# Access Compliance Report

## Public Rights-of-Way

### (Pedestrian Signals)

Intersection ID: N/A	Main Street:	Cross Street: N/A	Location: N/A
ADA ID: 9A8FD980C397	Signal Type: One Push Button-Non APS	Overall Compliance: No	Severity Score: BTN 1: N/A BTN 2: N/A No BTN: N/A
Codes/Mitigation Info/Possible Solution		Field Measurements/Component Compliance

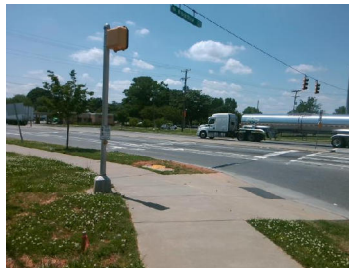
PROW/ADA: TMUTCD 4e.08, R404.7.2

N/A	B 1 Clear Xing Direction?	N/A	N/A	B 2 Clear Xing Direction?	N/A
	B 1 Crossing Direction	To NW		B 2 Crossing Direction	N/A
Yes	B 1 DistanceTo XWalk (in)	30.0	N/A	B 2 DistanceTo XWalk (in)	N/A
No	B 1 DistanceTo Curb (in)	162.5	N/A	B 2 DistanceTo Curb (in)	N/A
Yes	B 1 Diameter (in)	2.0	N/A	B 2 Diameter (in)	N/A

Possible Solutions: Replace Signal Push Button With APS Button on New Post. Remove & Relocate Sign.
